DEPARTMENT OF TRANSPORTATION

Contract #: 04-0120F4Cty: SF/ALA Rte: 80 PM: 13.2/13.9File #: 99.28**WELDING INSPECTION REPORT**

Report No: WIR-027053
Date Inspected: 17-Jan-2012

Project Name: SAS Superstructure
Prime Contractor: American Bridge/Fluor Enterprises, a JV
Contractor: L & M Industrial Fabricators

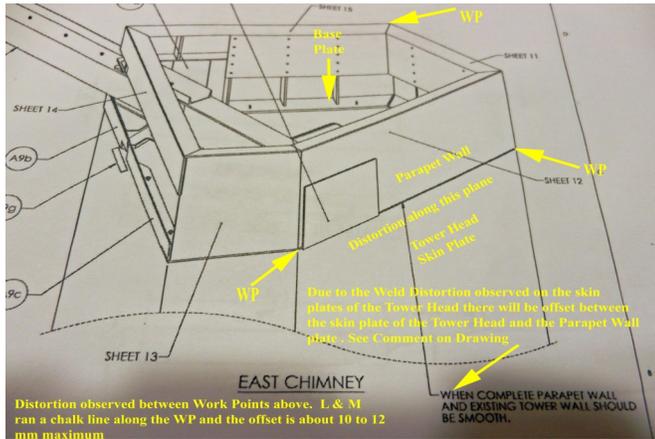
This QA Inspector randomly observed at (2) locations on the (East) tower head skin plates at the A11 and A12 sides of the parapet wall as shown on Submittal 2567 R1 page 10 of 16 that will fit to the tower head, weld distortion between the Work Points (WP) from the fabrication of the East Tower Head performed at ZPMC on

Changxing Island, China. L & M personnel ran a chalk line from WP to WP and observed a maximum of 12 mm difference between the chalk line from WP to WP to the edge of the Tower Head Skin plate at the aforementioned locations.

L & M management personnel are currently discussing their options with their Client the disposition and the means and methods to meet the drawing requirement that states "When complete parapet wall and existing tower wall should be smooth". See attached photo of the drawing and the note with the requirement to be smooth.
